ADDENDUM NUMBER 1

DINEEN PARK TENNIS COURTS
Site # 684
6901 West Vienna Street
Milwaukee, WI

Project Number: P462-14623

Date of Addendum: June 4, 2014

PROJECT NO.	P462-14623	SITE NO.	684	PROJECT TITLE	DINEEN PARK TENNIS COURTS
SHEET NO.	15A	BUILDING NO.		SHEET DESCRIPTION:	TENNIS COURT LIGHTING
				DATE	4/18/14
				DRAWN BY:	DSG
				CHECKED BY:	KDS
				SCALE	
				FILE NO.	15 OF 15

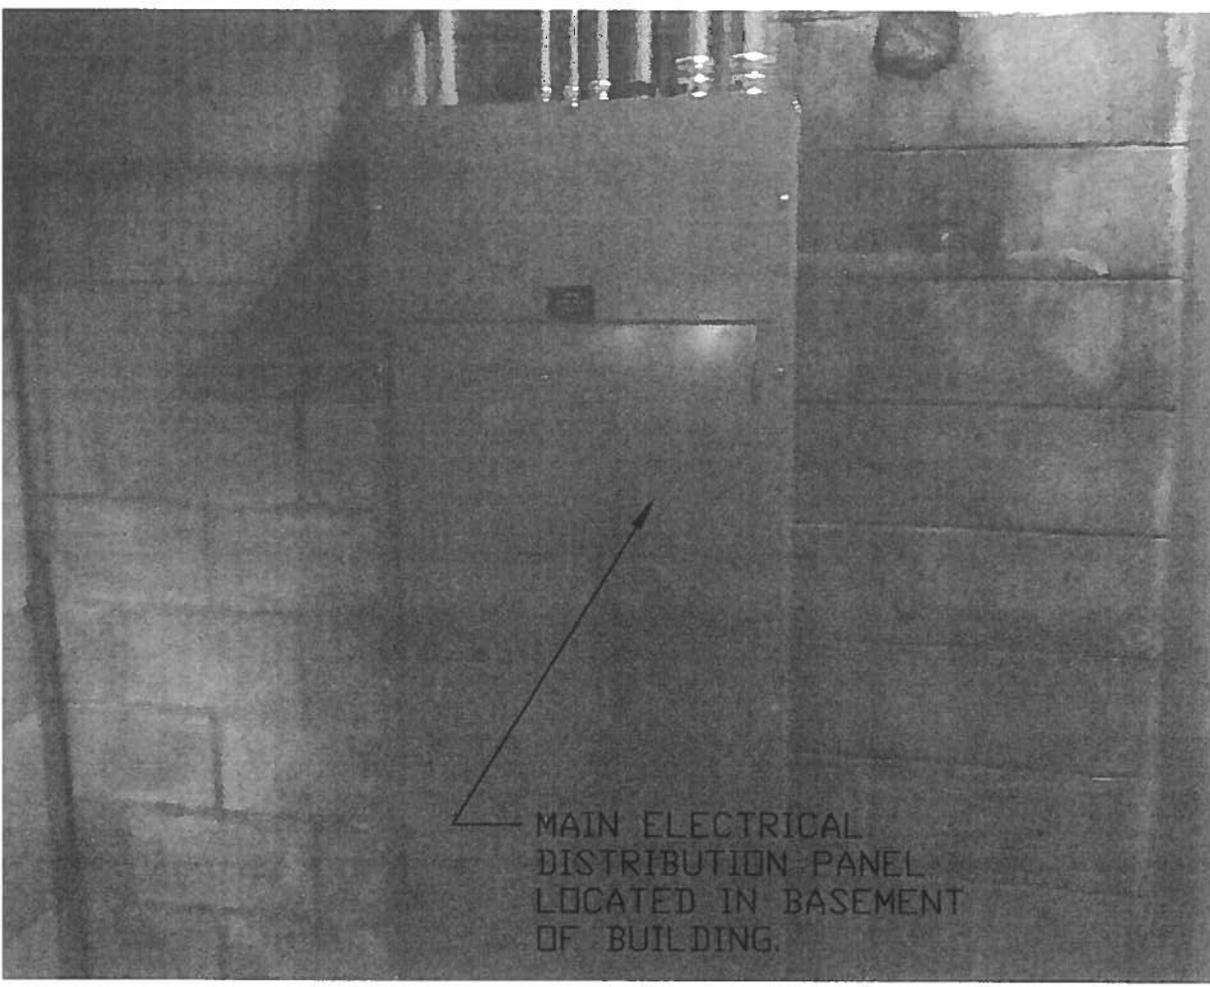
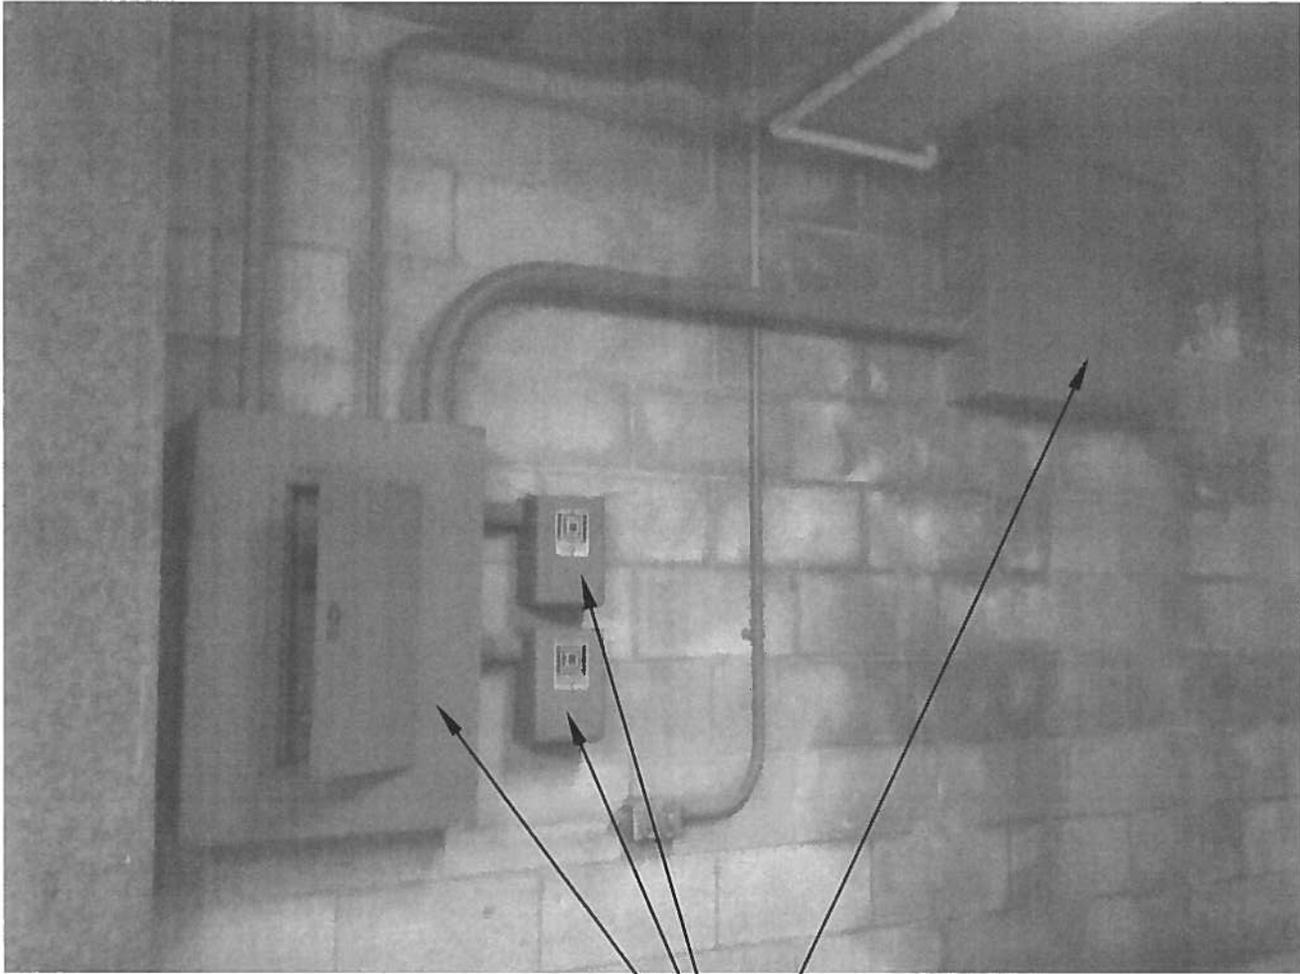
Remove Sheet 15 from plan set and replace with Sheet 15A attached to this addendum.

PROVIDE SURGE PROTECTION DEVICE AND CONTROL AND MONITORING CABINET AND MOUNT ON EMPTY WALL ADJACENT TO PANEL "C".

REMOVE AND SALVAGE EXISTING
PANEL "C" AND OTHER REMAINING
ELECTRICAL DEVICES AT OPPOSITE
END OF BASEMENT, +/- 75'

CONTRACTOR NOTE:
PROVIDE 100A FA SQUARE D BREAKER ON MAIN ELECTRICAL
DISTRIBUTION PANEL. RUN CONDUIT AND WIRE PER NEC
CODE TO CONTROL AND MONITORING CABINET.

SEQUENCE OF OPERATION (Control-Link):

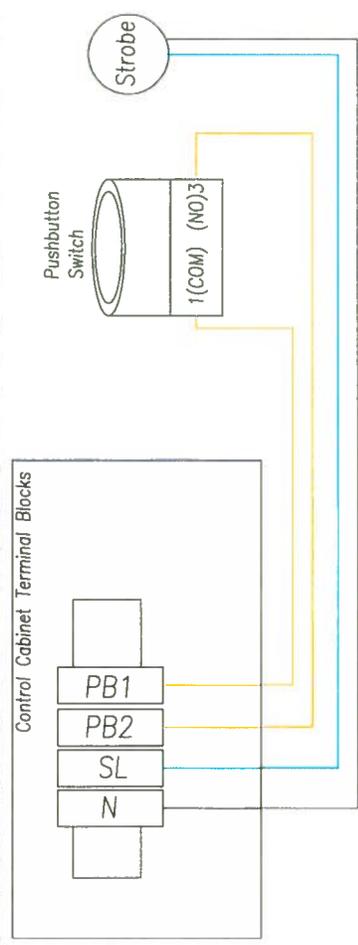
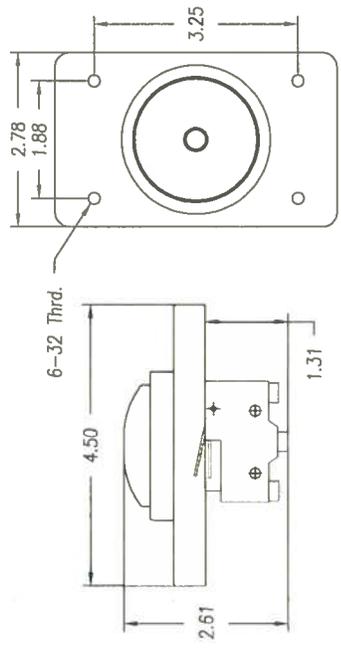
Add Push Button detail sheet to tennis court lighting. Cost for push button and associated work to be included with Bid Item #41.

1. The OOA needs to be in the AUTO position. A schedule begins and the REC closes the I/O relay which sends control power to the pushbutton.
2. The pushbutton is pressed to turn on the lights. The contactors pull in, which also activates the holding circuit. The lights remain ON for the preset amount of time dictated by the timer dial T1 (Bottom Dial).
3. The timer times out and performs 2 functions.
 - 3.1. Power from the timer is sent to the strobe as a warning that the lights will extinguish in 'X' amount of time (dictated by dial T2 (Top Dial)), to turn off.
 - 3.2. The timer activates a count down for the circuit to turn off.
4. If the pushbutton is pressed again, before the strobe turns off, the lights will remain ON for another cycle.
5. If the pushbutton is NOT pressed again the strobe and lights will extinguish.

- 2 wires for the pushbutton (12 AWG)
- 2 wires for the strobe light (12 AWG)

Control System Summary

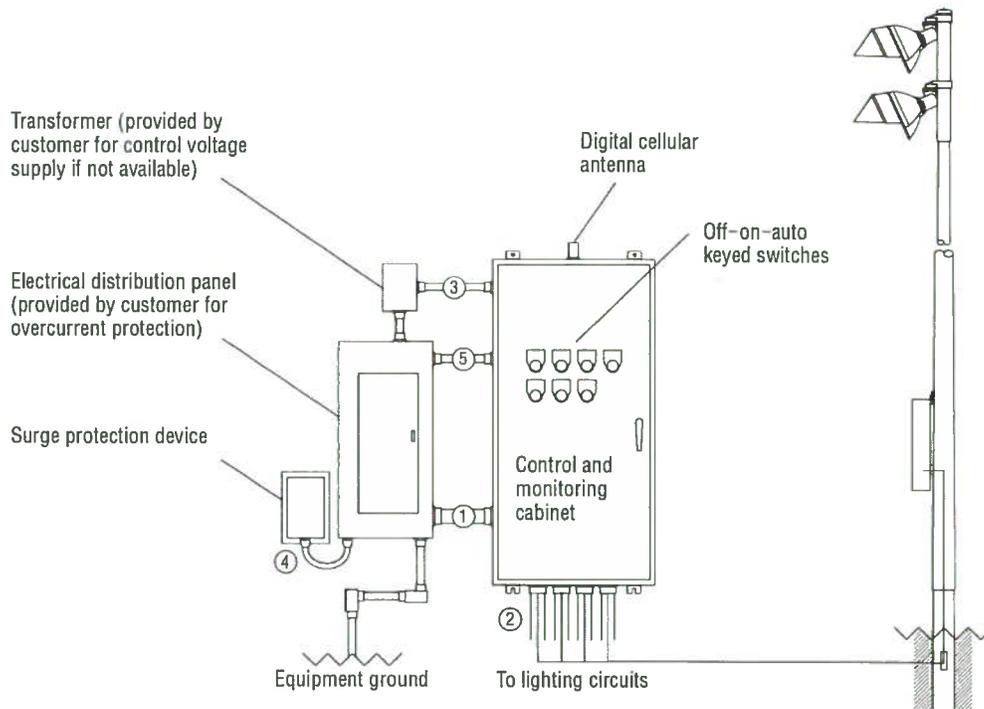
Remove Musco Lighting Control Summary Sheets from specifications and Replace with revised Musco Lighting Control System Summary Sheets A-1 through Sheet A-4

SINGLE LINE DISTRIBUTION

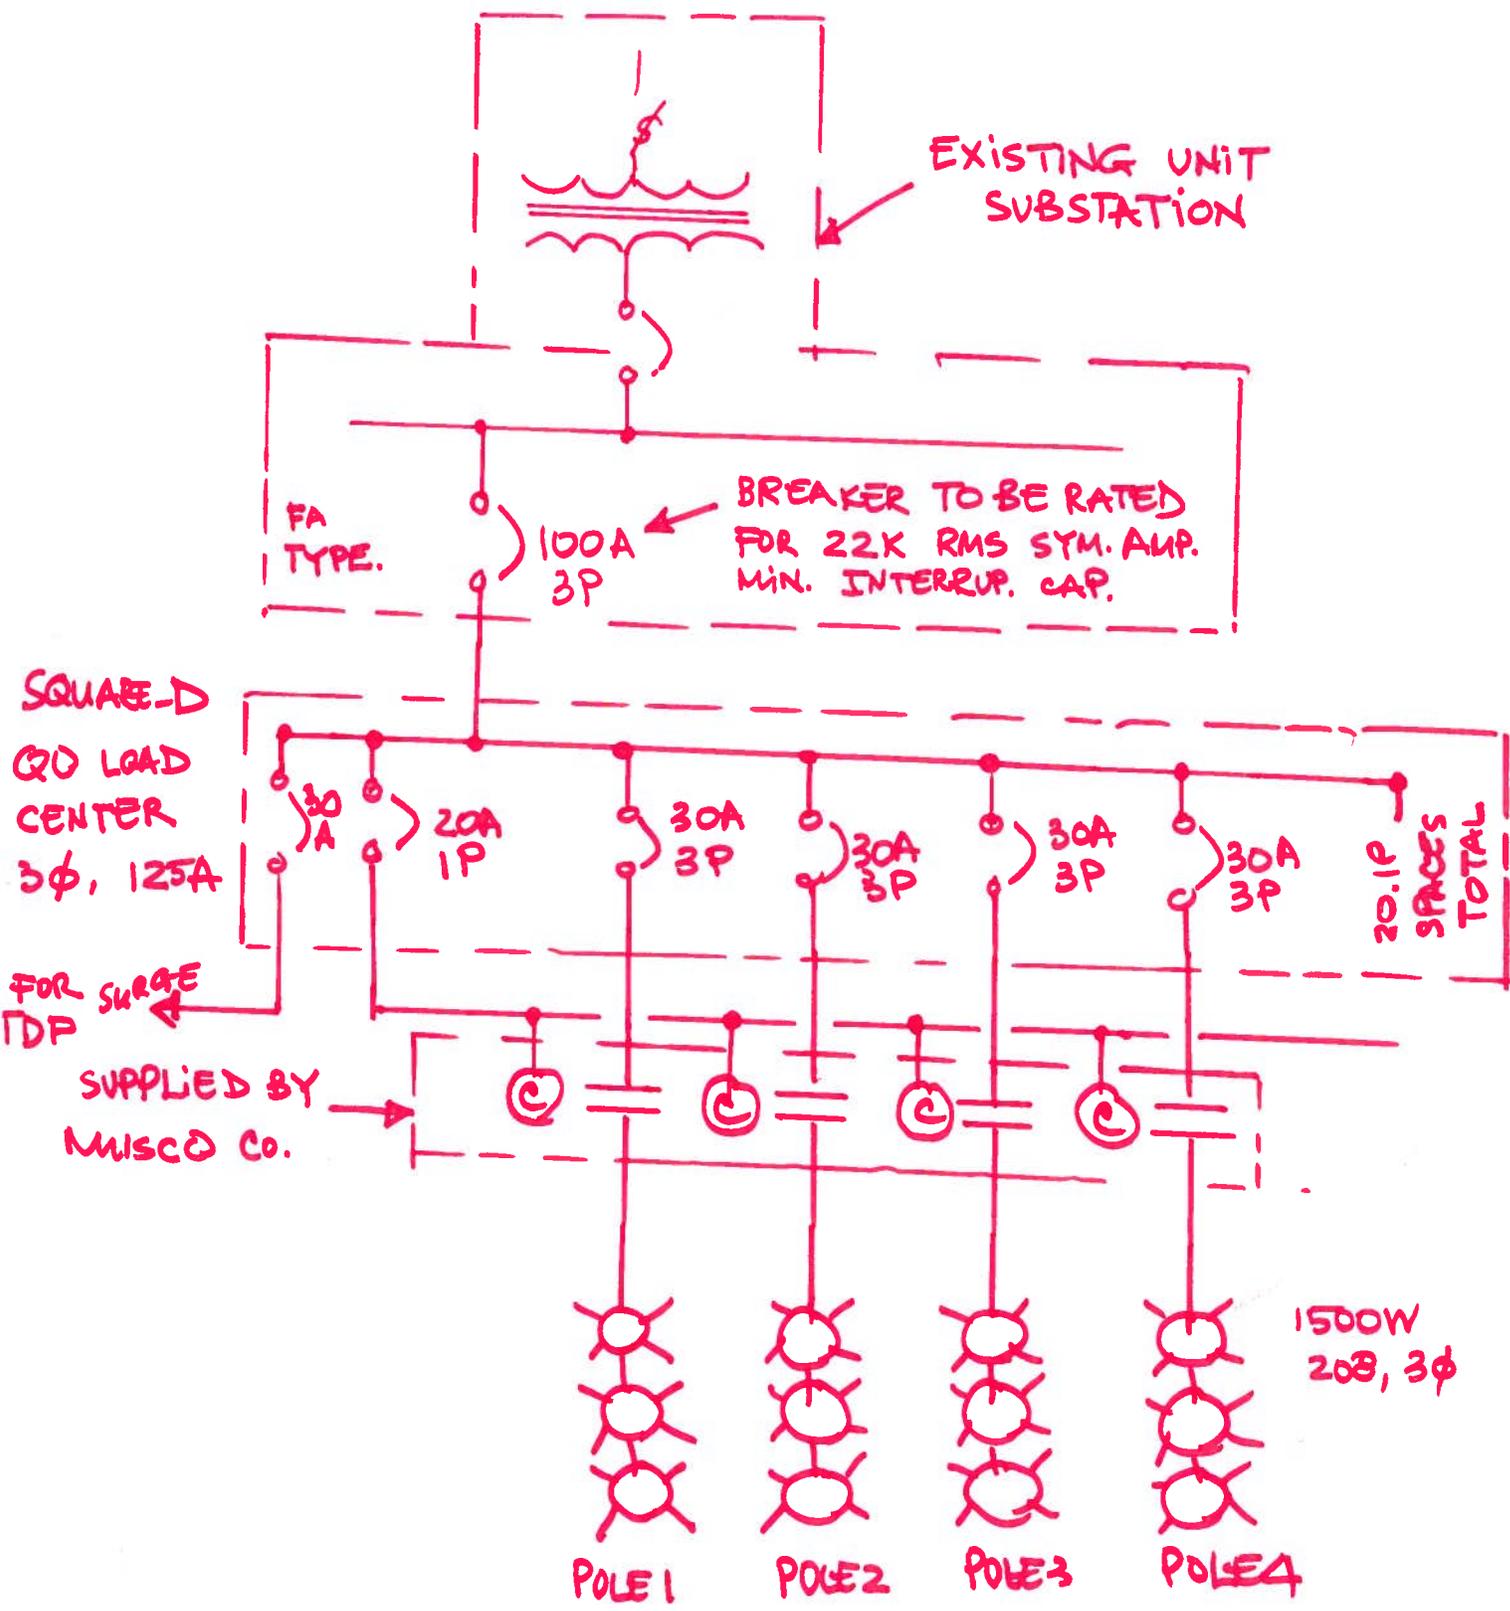
Add Single Line Distribution for clarification of electrical system
